19/13-94A. 19215 Blunt Avenue
Germantown Historic District

APPLICATION FOR HISTORIC AREA WORK PERMIT

HISTORIC PRESERVATION COMMISSION STAFF REPORT

Address: 19215 Blunt Avenue Meeting Date: 09/28/94
Resource: Germantown Historic District HAWP: Alterations/
Addition
Case Number: 19/13-94A CONTINUED Tax Credit: No
Public Notice: 09/14/94 Report Date: 09/21/94
Applicant: Raymond & Julie Howar Staff: Patricia Parker
PROPOSAL: Rear Addition RECOMMEND: Approval w/
condition

FLOOR PLANS

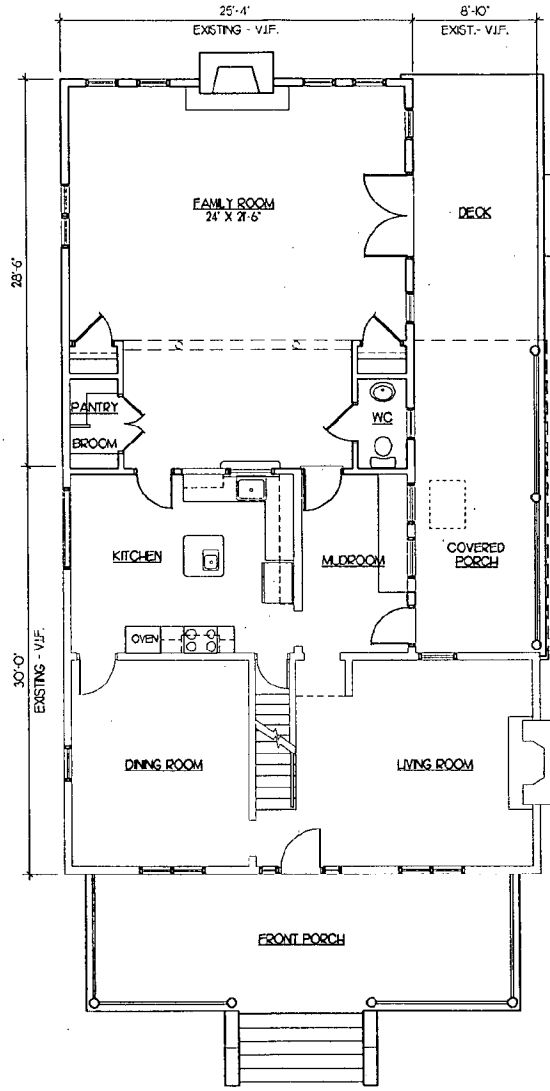
In the interim and as requested, the applicant has submitted new drawings, manufacturer's catalogue cuts and photographs of the property as it exists today. As the HPC had recommended, the drawings are changed to indicate a 4" recess at both the first and second levels on the side elevation (see SK-5A drawing #3); but the plans do not agree with the elevations (see SK-5 drawing #1). Staff assumes on the first floor the indentation will occur in the area of the pantry/broom closet on the first floor.

Further changes from the earlier submission indicate that many of the window openings have been reconfigured. Staff feels that they are now more compatible with the historic structure. Staff would suggest reworking the second floor interior plan at the rear of the new addition to permit an opening at this level and to capture southern exposure. The new window could align with one at the lower level.

EXTERIOR ELEVATIONS

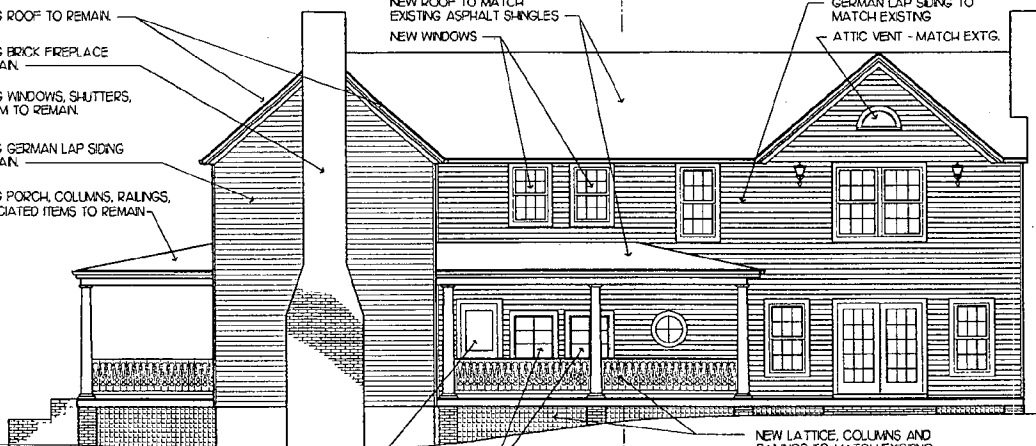
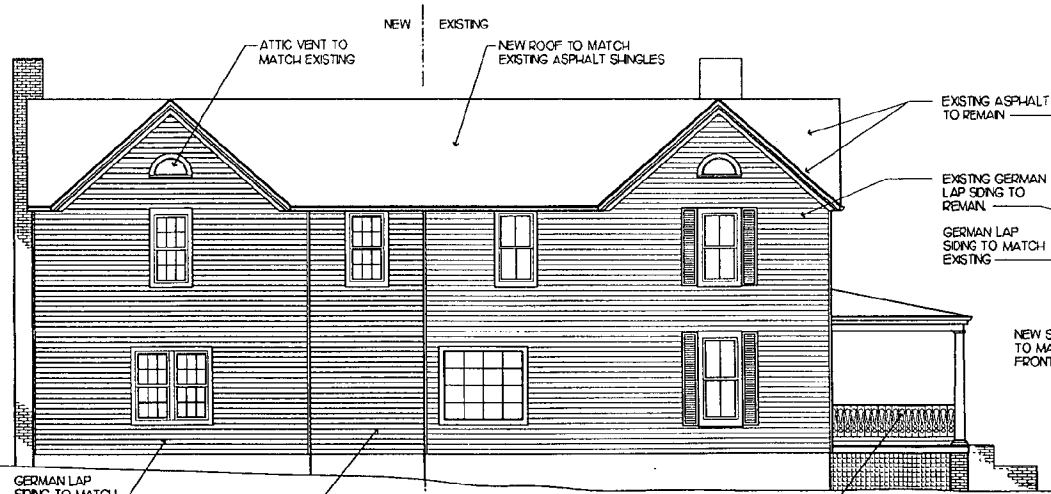
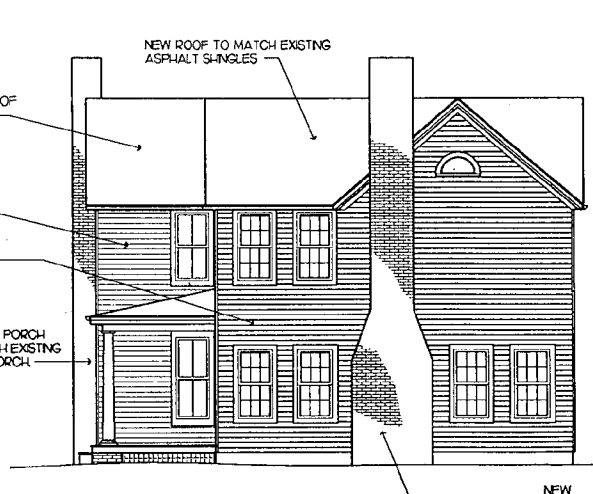
But staff is concerned that the applicant proposes to utilize snap-in muntins within the window openings. The manufacturer's catalogue cuts also indicate vinyl-clad wood windows. Staff would recommend that the applicant use wood windows with true divided light. Wood trim should match the existing as close as possible. Staff is pleased that the applicant has chosen to sheathe the addition in German lap siding to match the existing. Therefore, staff feels that the use of wood windows with true

The drawings now indicate that shutters will be present on only the original portion of the house. Windows in the new section will not receive shutters.

One of the window openings of the existing mudroom will be changed and enlarged to become a new door opening serving as egress to the new covered porch. Staff does not find this solution for egress problematic.

1. Windows in the addition shall be wood with true divided light set in wood framing and trim to match the existing trim.

**EXTERIOR
ELEVATIONS**

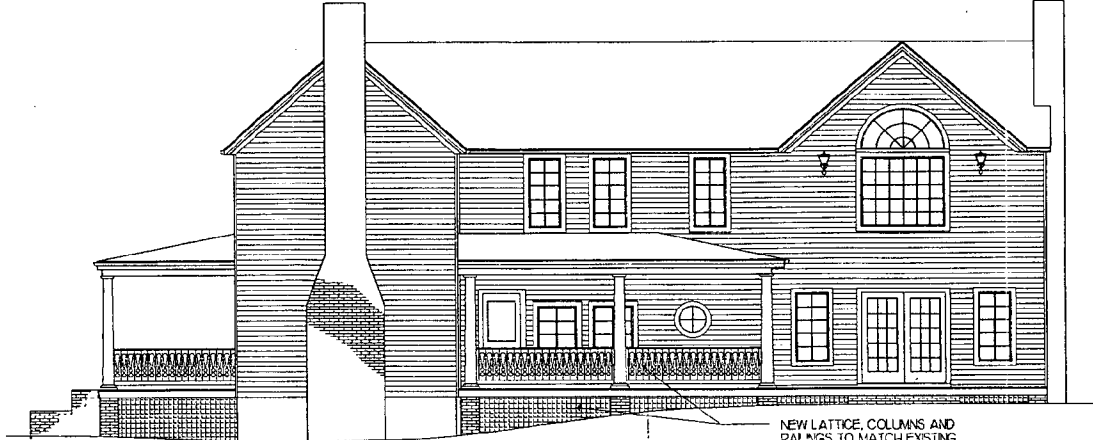
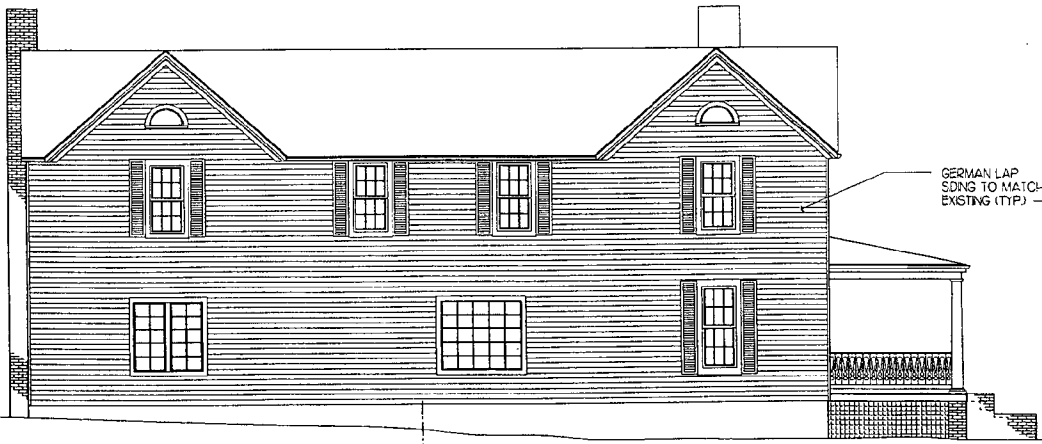
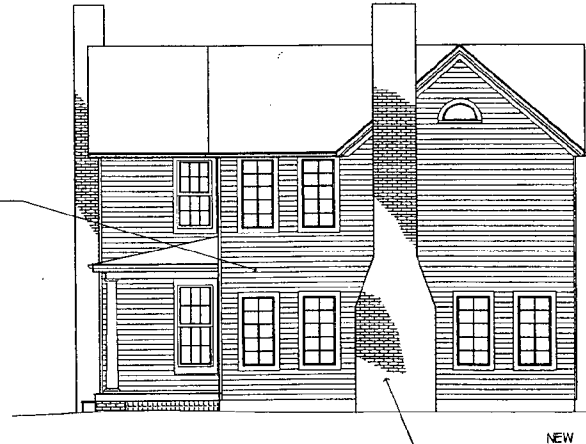
Staff has a number of concerns about this application - some of which relate to confusing or incomplete portions of the submission. For example, window openings in the 1890's structure have metal casement windows on the Blunt Avenue side and 1/1 on the front elevation. However, the application shows 6/6 windows on the front elevation of the existing house. It is not clear if this is a proposed change or a drafting error.

A site visit further indicates that replacement of latticework at the right side under the porch has occurred. This existing treatment is different than that shown in the proposal. Staff feels that as part of construction, this area of latticework at the front of the property should be re-worked to match the latticework at the left under the porch floor and as shown on the submitted plans.

In terms of the rear addition, staff applauds the applicant's decision to orient the addition to the rear of the structure and to use wood lap siding as sheathing. However, staff is concerned that the new addition is undifferentiated from the existing historic house. The new addition could be recessed somewhat from the exterior wall of the existing structure on the east and west elevations, and a change in the height of the roof of the addition might also help to differentiate the old from the new.

Staff finds the choice of openings, both size and configuration for windows in the new addition problematic. Some are incompatible with the style and period of the structure - particularly the large "picture window" type openings. The HPC may choose to comment further on this issue. Staff notes that most window openings on the east elevation have shutters; whereas, windows on the west elevation which front a principal street are without shutters. This is a confusing treatment for the structure, but may also be a drafting error. More clarification is needed.
